Access Compliance Report

Public Rights-of-Way

Intersection ID: 12333	Main Street: N_BREVARD_ST	Cross Street: E_7TH_ST	Location: S
ADA ID: 0F83CA4A7D82	Ramp Type: PerpDiag	Initial Pass/Fail: Fail	Overall Compliance: No
Severity Score: 18.75			
Codes/Mitigation Info/Possible Solution		Field Measurements/Component Compliance

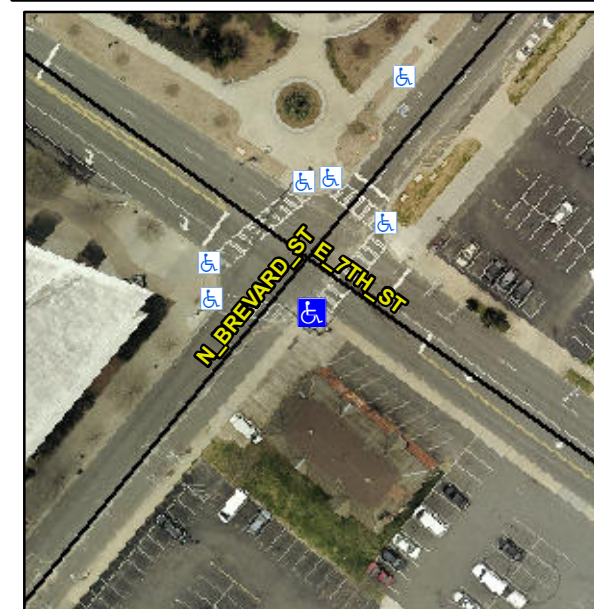
Remove & Replace Curb Ramp With Two New Directional Ramps or Equivalent. Restripe Crosswalk.

R304.5.1
